SIB 11 01 22

2022-06-28

RECALL 22V-119: POSITIVE CRANKCASE VENTILATION (PCV) BLOW-BY HEATER

This Service Information Bulletin (Revision 2) replaces SI B11 01 22 **dated March 2022**.

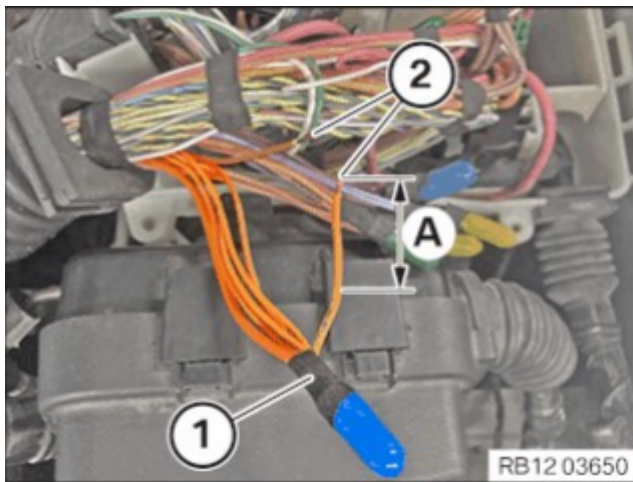
Repair Instruction 00 72 067 “Retrofitting component protection and checking function of angle fitting” indicates the splice cap is blue, this is not the actual color of the splice cap.

The picture has been edited to highlight the splice cap with blue coloring (1).

Install P/N 12 51 5 A6A 0E2 “Cable Harness Repair Kit” as per Repair Instruction 00 72 067 “Retrofitting component protection and checking function of angle fitting”.

E60 & E61 Vehicles:

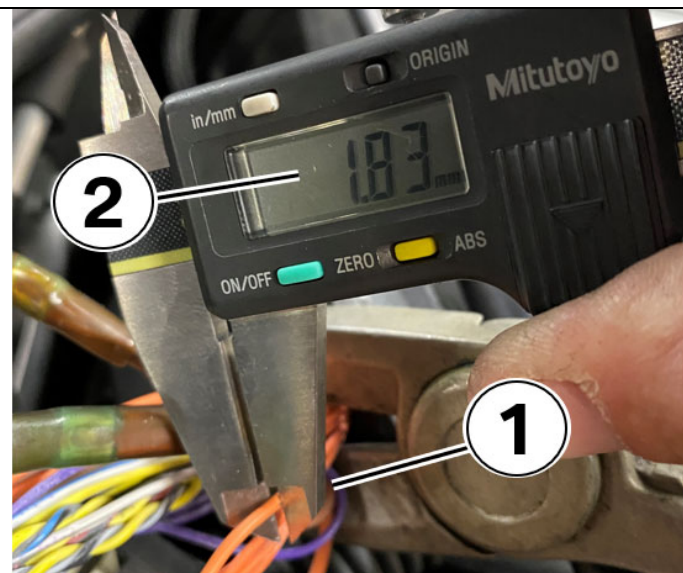
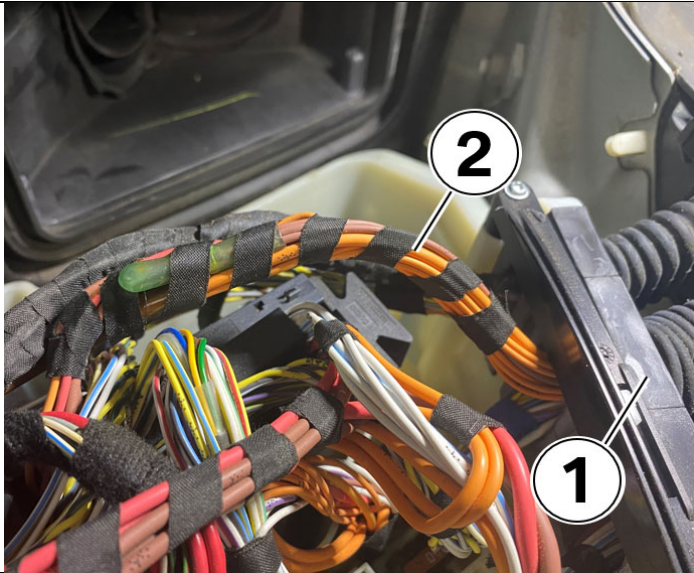
Locate the middle harness (1) in the e-box.

Unwrap the tape from the harness (2).

Under the tape there will be several splices with orange colored wire (1).

Select the splice that has exactly 6 orange wires in it.

To identify the correct wire a digital caliper must be used to ensure accuracy. Use the digital caliper to measure the outside diameter (1) of each wire in this splice. Do not separate the splice.

In this example the correct wire is measured at 1.83 mm.

Wire outside diameter specifications:

1 wire = 2.15 - 2.40 mm – Incorrect wire

1 wire = 1.70 – 1.90 mm – Correct wire

4 wires = 1.35 – 1.55 mm – Incorrect wire

Select the wire that measures between 1.70 – 1.90 mm (1) and continue with Repair Instruction 00 72 067 “Retrofitting component protection and checking function of angle fitting”.

E70 Vehicles:

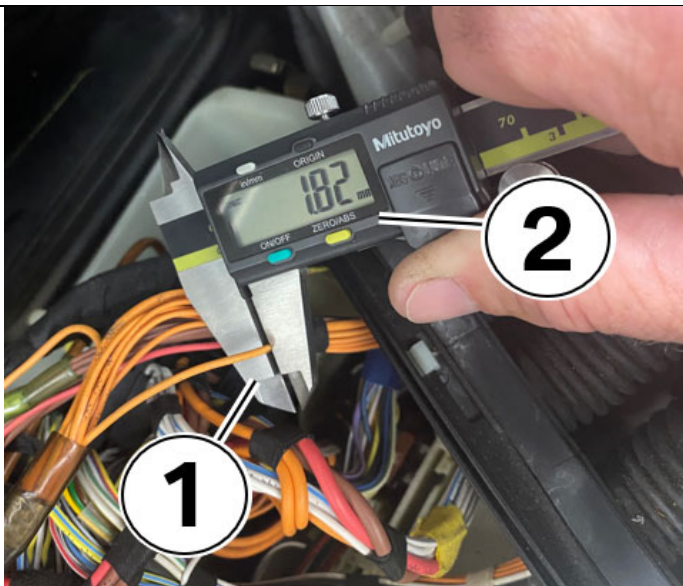
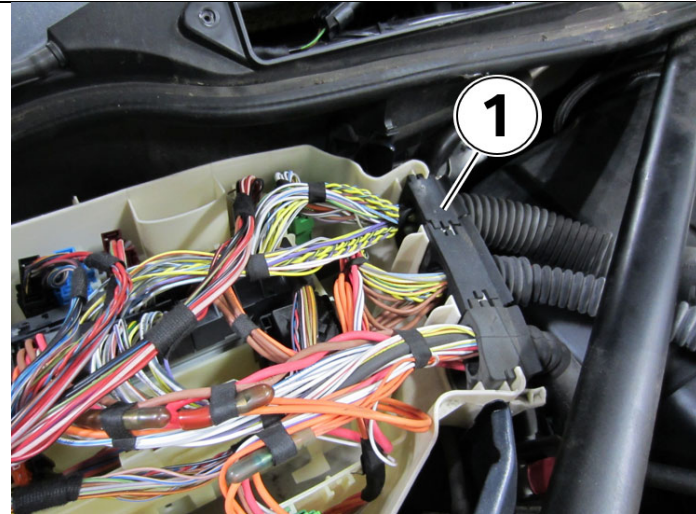
Locate the middle harness (1) in the e-box.

Unwrap the tape from the harness (2).

Under the tape there will be several splices with orange wire.

Select the splice that has exactly 8 orange wires in it.

To identify the correct wire a digital caliper must be used to ensure accuracy. Use the digital caliper to measure the outside diameter (1) of each wire in this splice. Do not separate the splice.

In this example the correct wire is measured at 1.82 mm.

Wire outside diameter specifications:

1 wire = 2.80 – 3.10 mm – Incorrect wire

1 wire = 1.90 – 2.10 mm – Incorrect wire

1 wire = 1.70 – 1.90 mm – Correct wire

5 wires = 1.40 – 1.60 mm – Incorrect wire

Select the wire that measures between 1.70 – 1.90 mm (1) and continue with Repair Instruction 00 72 067 "Retrofitting component protection and checking function of angle fitting".

E82, E88, E90, E91, E92 and E93 Vehicles:

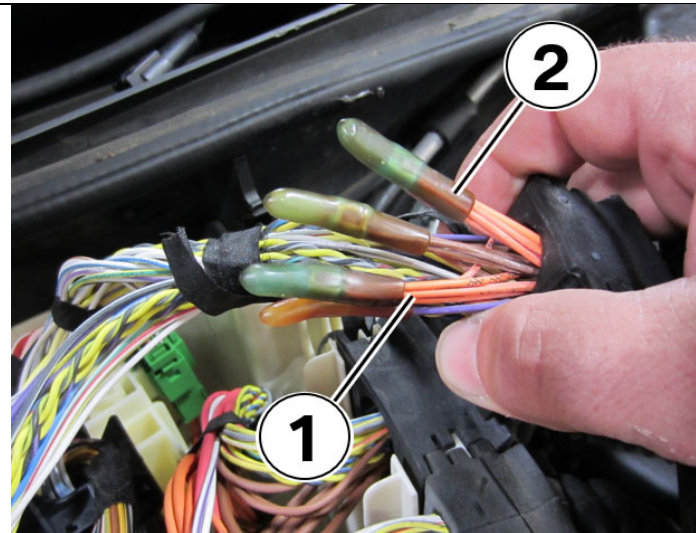
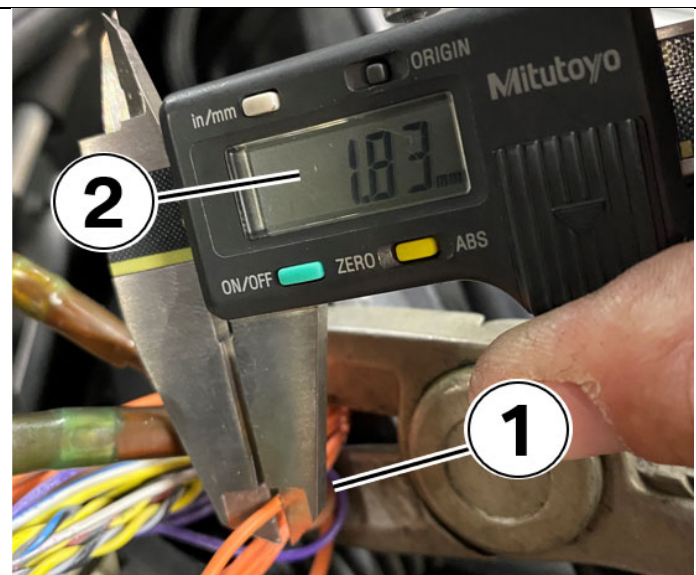
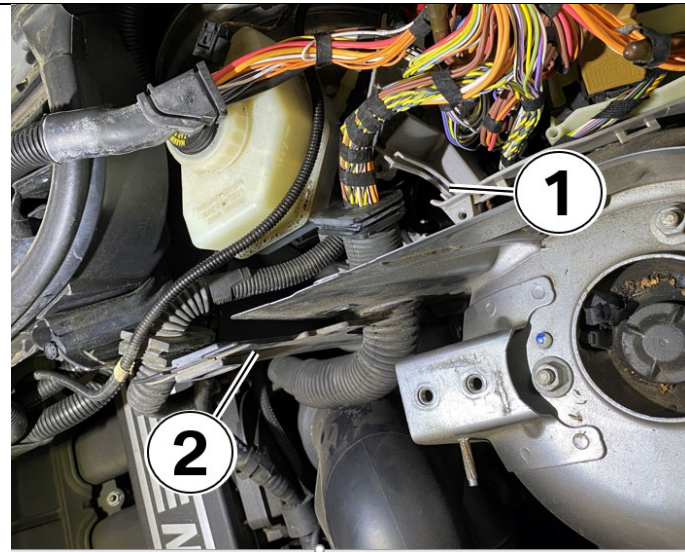
Locate the harness (1) at the rear corner of the e-box.

The splice will be located under the soft rubber boot, you will need to remove the harness from the e-box and pull back the rubber boot to expose them.

Unwrap the tape from the harness.

Under the tape will be several splices with orange wire, select the splice that has exactly 6 orange wires in it.

To identify the correct wire a digital caliper must be used to ensure accuracy. Use the digital caliper to measure the outside diameter (1) of each wire in this splice. Do not separate the splice.

In this example the correct wire is measured at 1.83 mm.

Wire outside diameter specifications:

1 wire = 2.15 – 2.40 mm – Incorrect wire

1 wire = 1.70 – 1.90 mm – Correct wire

4 wires = 1.35 – 1.55 mm – Incorrect wire

Select the wire that measures between 1.70 – 1.90 mm (1) and continue with Repair Instruction 00 72 067 “Retrofitting component protection and checking function of angle fitting”.

E83 Vehicles:

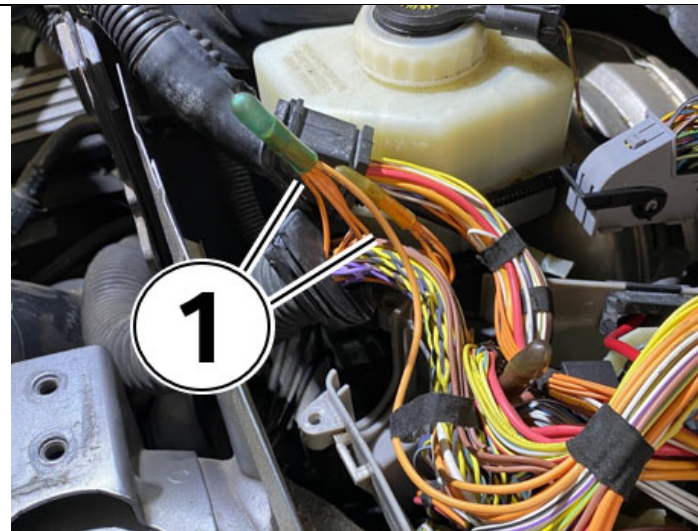
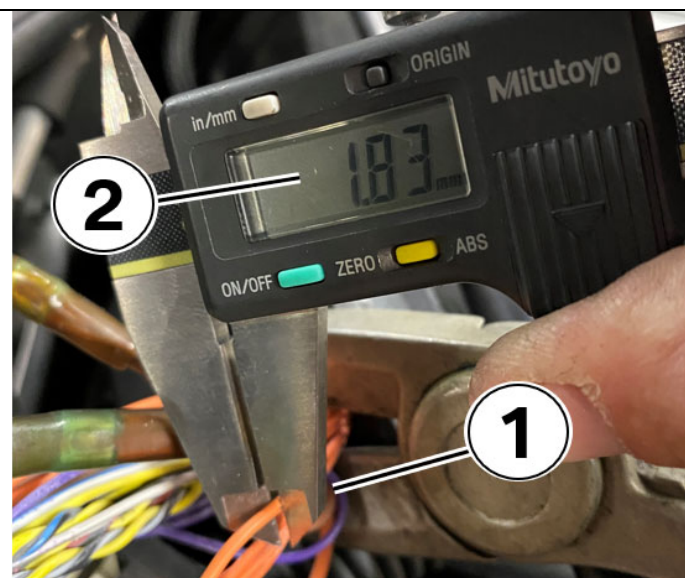
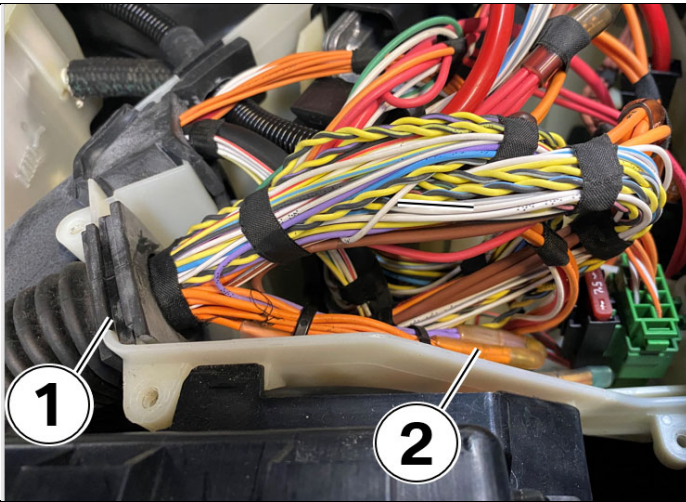
Locate the harness (1) at the front corner of the e-box.

You will need to loosen the surrounding plastic trim (2) to access the soft rubber boot.

The splice will be located under the soft rubber boot, you will need to remove the harness from the e-box and pull back the rubber boot to expose them.

For photo clarity the strut brace was removed. Do not remove the strut brace to perform this procedure.

Under the tape there will be several splices with orange wire, select the splice that has exactly 6 orange wires in it.

To identify the correct wire a digital caliper must be used to ensure accuracy. Use the digital caliper to measure the outside diameter (1) of each wire in this splice. Do not separate the splice. In this example the correct wire is measured at 1.83 mm.

Wire outside diameter specifications:

1 wire = 2.15 – 2.40 mm – Incorrect wire

1 wire = 1.70 – 1.90 mm – Correct wire

4 wires = 1.35 – 1.55 mm – Incorrect wire

Select the wire that measures between 1.70 – 1.90 mm (1) and continue with Repair Instruction 00 72 067 "Retrofitting component protection and checking function of angle fitting".

E85 & E86 Vehicles:

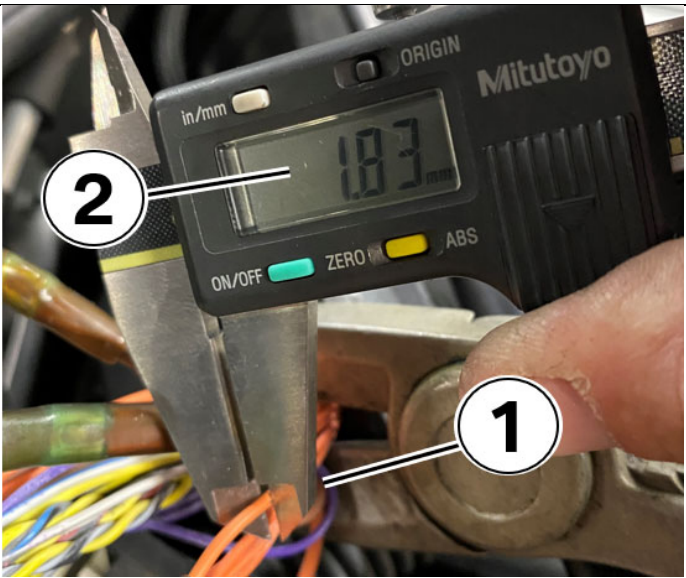
Locate the harness (1) at the front corner of the e-box.

In this particular application the splices are already exposed (2).

There will be several splices with orange wire, select the splice that has exactly 6 orange wires in it.

To identify the correct wire a digital caliper must be used to ensure accuracy. Use the digital caliper to measure the outside diameter (1) of each wire in this splice. Do not separate the splice.

In this example the correct wire is measured at 1.83 mm.

Wire outside diameter specifications:

- 1 wire = 2.15 – 2.40 mm – Incorrect wire
- 1 wire = 1.70 – 1.90 mm – Correct wire**
- 4 wires = 1.35 – 1.55 mm – Incorrect wire

Select the wire that measures between 1.70 – 1.90 mm (1) and continue with Repair Instruction 00 72 067 "Retrofitting component protection and checking function of angle fitting".
